ADDENDUM #2

CITY HALL ELECTRICAL UPGRADE

BID #13/14-003 – PWP# WA-2013-292

E0.1

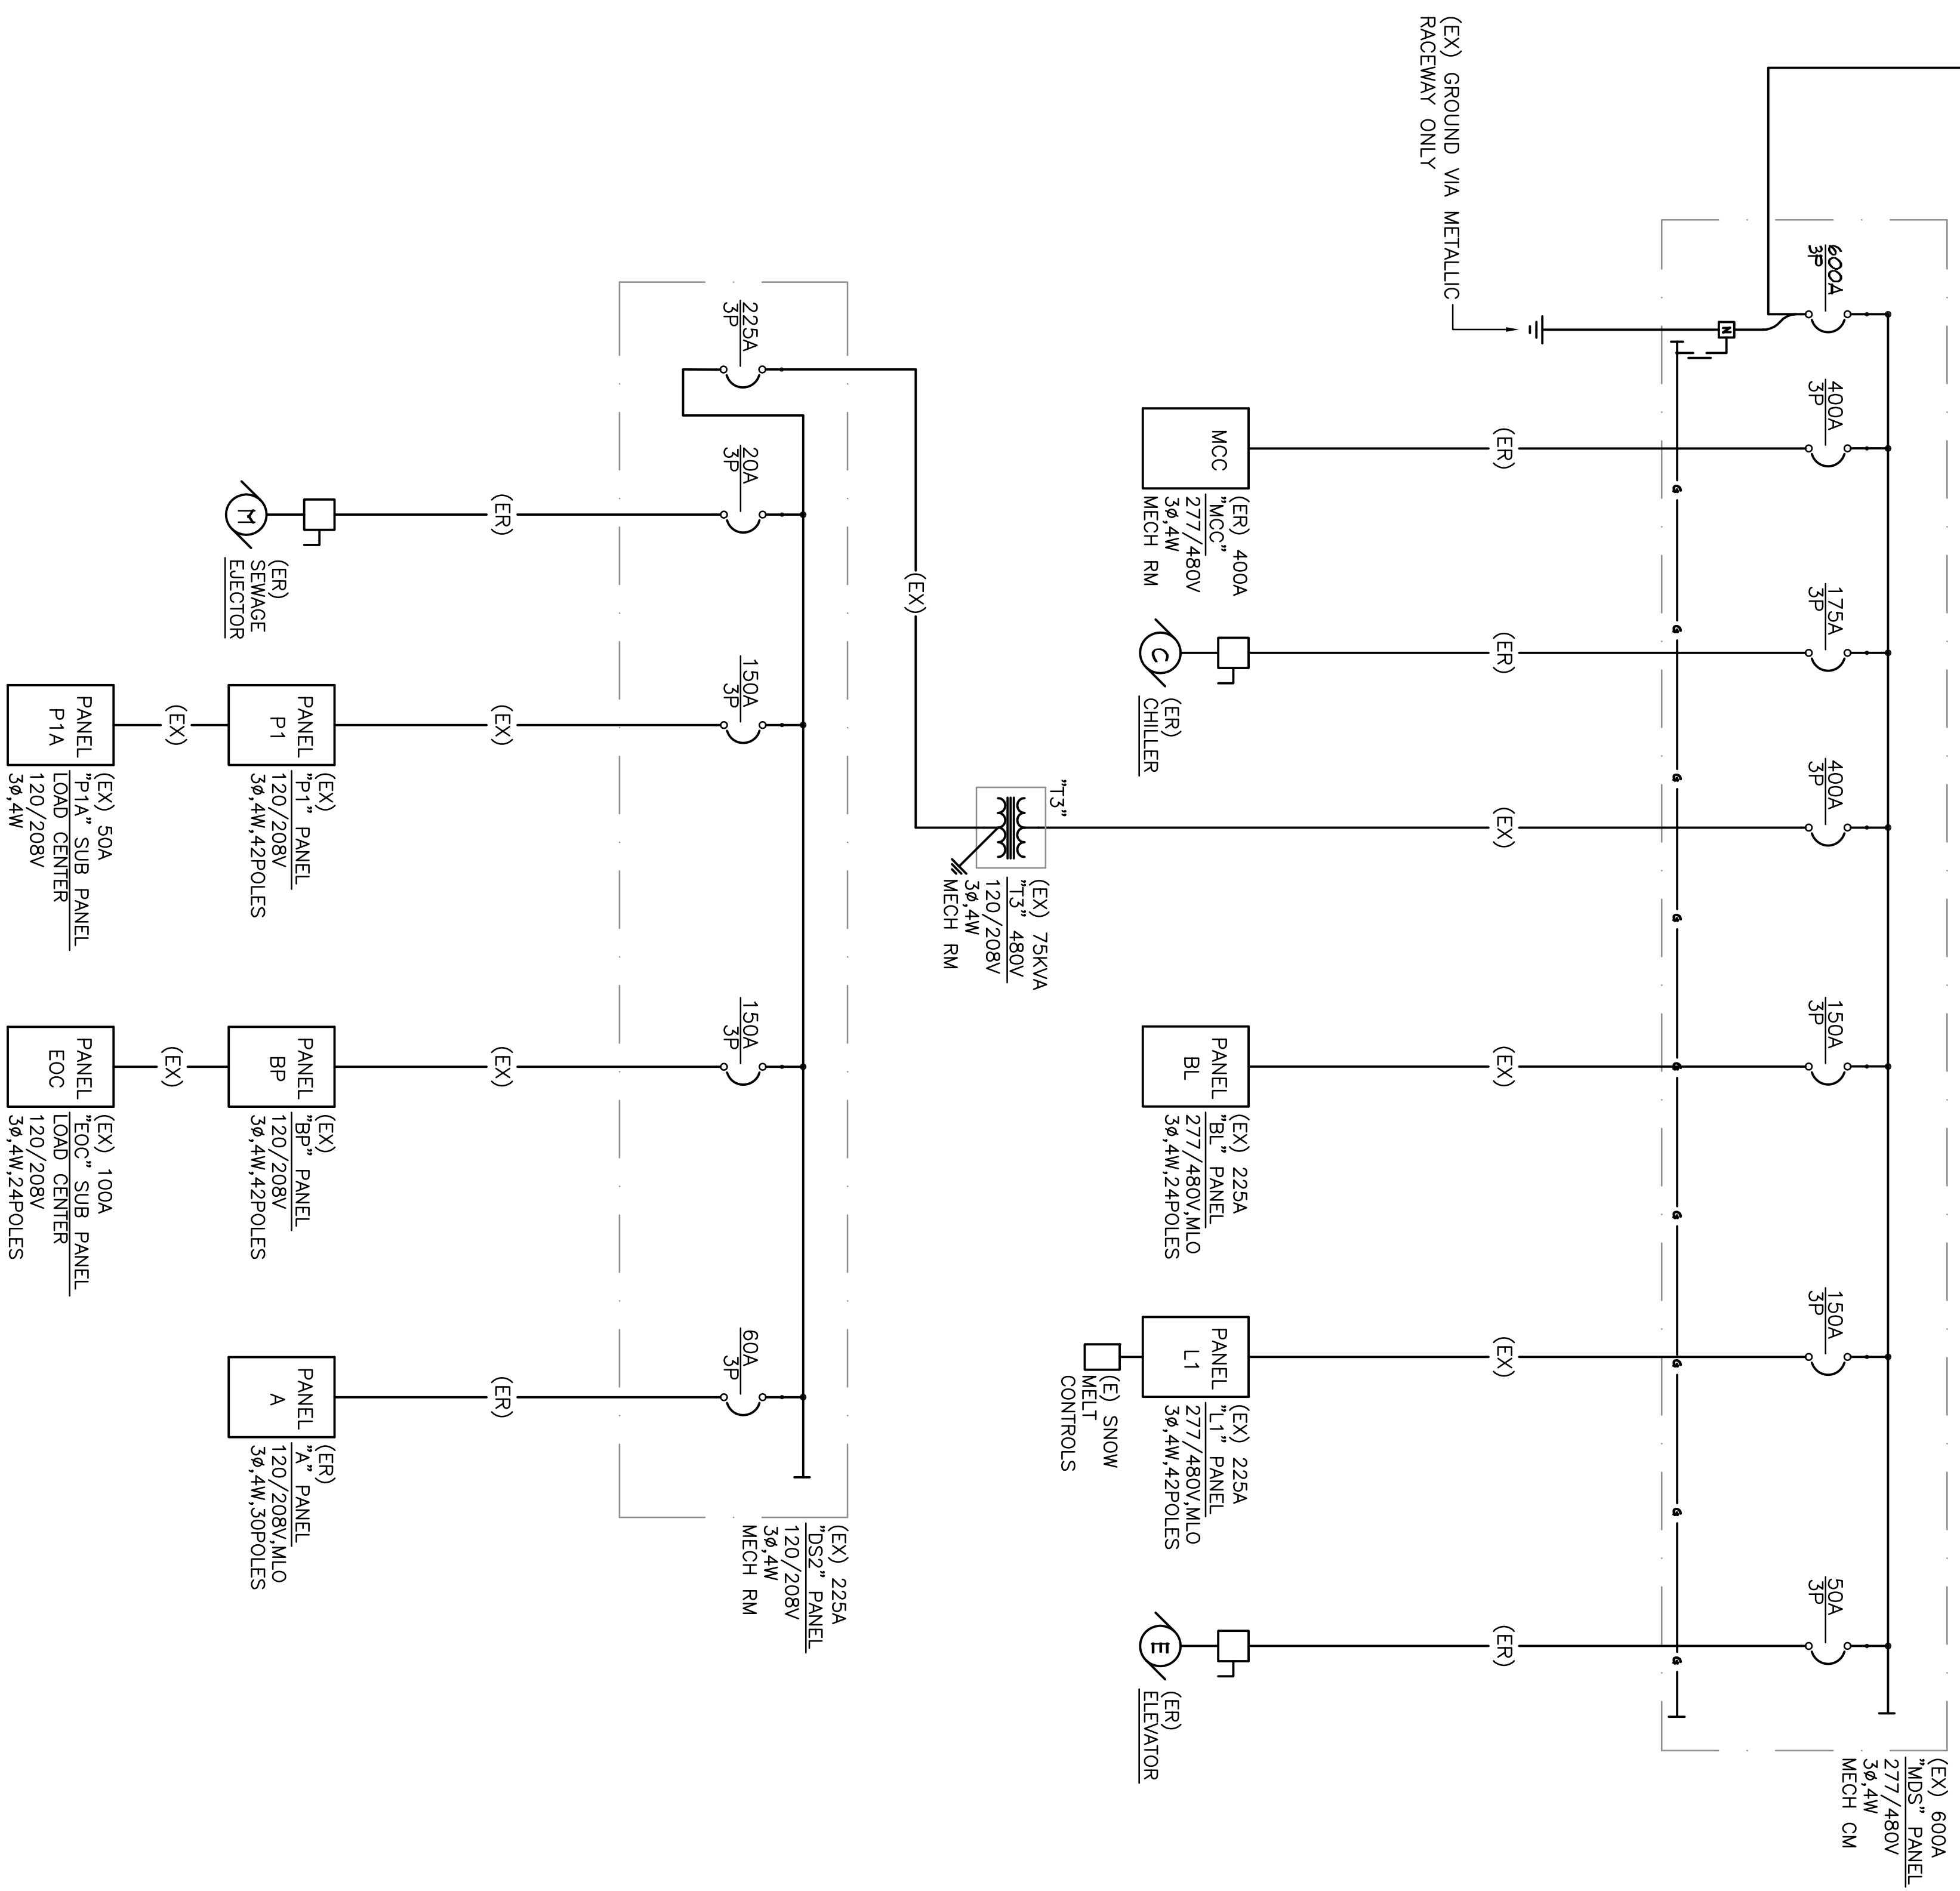
- a) E0.1: Added "Building Code Summary" per plan check comments and added code requirements for the contractor for use during construction.
b) E1.2: Changed "New Panel Schedule" item #2 to read panel '1A'.

BUILDING CODE SUMMARY

APPLICABLE DESIGN CODES (latest edition as adopted by the City of Sparks)
 INTERNATIONAL BUILDING CODE (2009)
 NATIONAL ELECTRICAL CODE (2005)
